Service Bulletin

MOTORCYCLE DIVISION
GS/GSX/GSXR NO. 224
DATE: 05/23/2012

**Sidestand Switch Bolt
Replacement Campaign: 2A29**

SUBJECT: GSX-R1000K9-L1 Recall Campaign – Sidestand Switch Bolt Replacement

WASHERS (6.5 x 16 x 1)

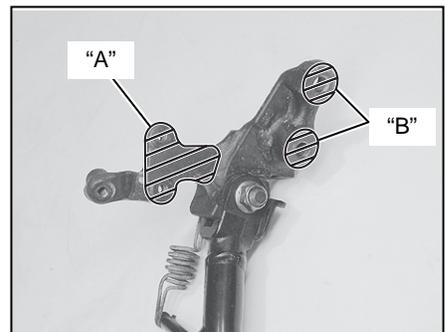
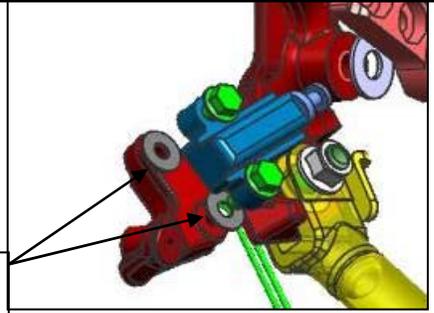
- Set the sidestand to the lowered position.
- Install the sidestand switch to the sidestand bracket with new bolts and washers. Washers should be installed between the switch and bracket as shown.
- Tighten sidestand switch bolts to the specified torque.

Sidestand switch bolt (a): 10 N·m (1.0 kgf-m, 7.0 lbf-ft)

WASHERS (10.5 x 24 x 1.6)

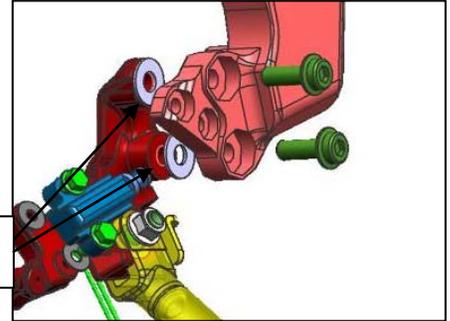
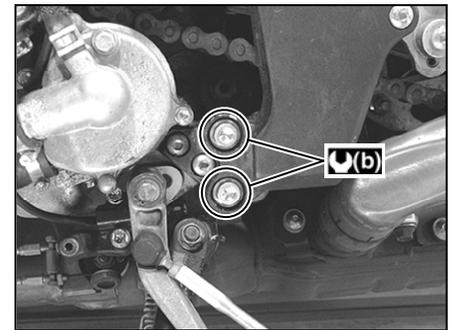
- Install the sidestand bracket with new bolts and washers. Washers should be installed between the frame and bracket as shown.
- Tighten sidestand bracket bolts to the specified torque.

Sidestand bracket bolt (b): 50 N·m (5.0 kgf-m, 36.0 lbf-ft)
